RESOLUTION HOLDING HEARING ON REQUEST FROM CASEY'S MARKETING COMPANY (OWNER), REPRESENTED BY MELANI SAMORA (AGENT), TO REZONE PROPERTY LOCATED AT 4560 AND 4570 EAST 14TH STREET

(ZON2014-00215)

Communication from the City Plan and Zoning Commission advising that at their meeting held November 20, 2014, the following action was taken regarding a request from Casey's Marketing Company (owner) represented by Melani Samora (agent) to rezone property located at 4560 and 4570 East 14th Street. Additional subject property is owned by V&C Real Estate, LLC.

4 Pump Island Canopy - (Street Side)
1/8" = 1'-0"

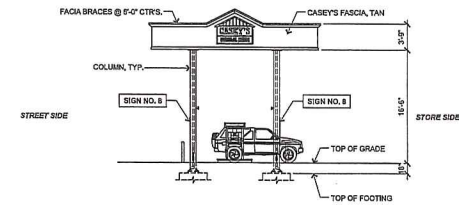
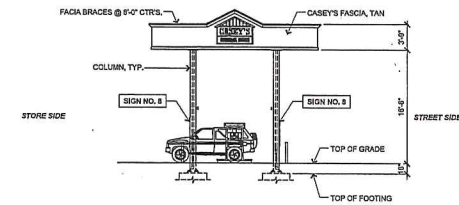
- 4) Provision of a canopy design elevations demonstrating compliance with all design guidelines for gas stations/convenience stores including flush mounted lighting and support columns that are clad in masonry material to match the primary building. Overall canopy heights should not exceed 22 feet inclusive of sign elements. All proposed canopy sign allowances shall be included on the elevations or with an overall sign plan sheet.

Pylon Sign - 3 Product Horizontal

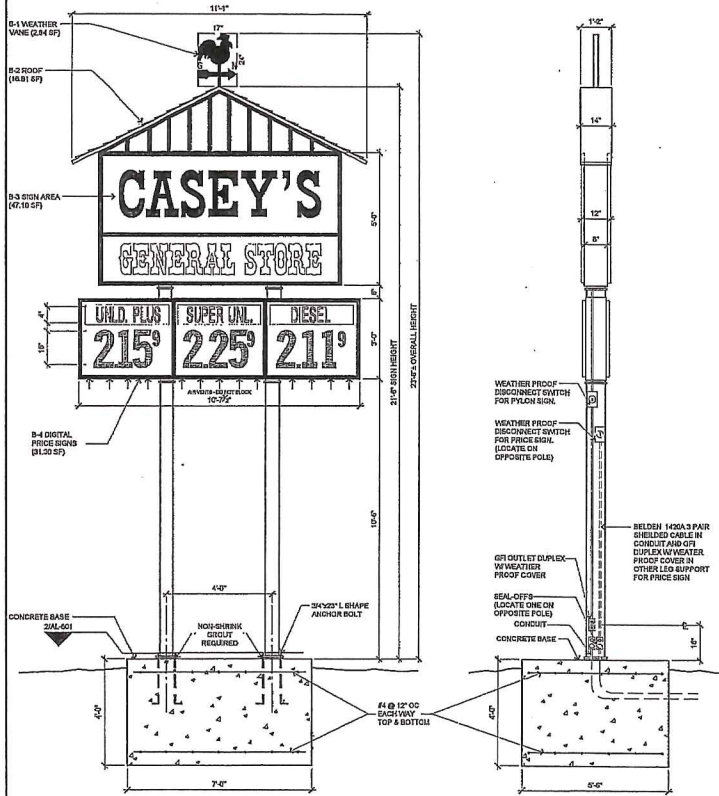
- 6) Limit the applicant to one freestanding sign of existing height if a brick base is provided around and between the columns to make it look like a monument sign.

- 6) Elimination of the existing pole sign. Any freestanding signs shall be monument signs with an approved sign elevation sheet as part of any PUD Conceptual Plan. Freestanding monument signs within 25 feet of the Right-Of-Way shall not exceed 12 feet in height and with all other freestanding monument signs not to exceed 15 feet in height if setback more than 25 feet.

Wally Pelds stated they would probably not want to lower the sign. He would ask for a variance if he had too. There have been no complaints about the sign and they would like to keep it where it is, dress it up with digital display on the bottom so they can change the fuel price numbers.
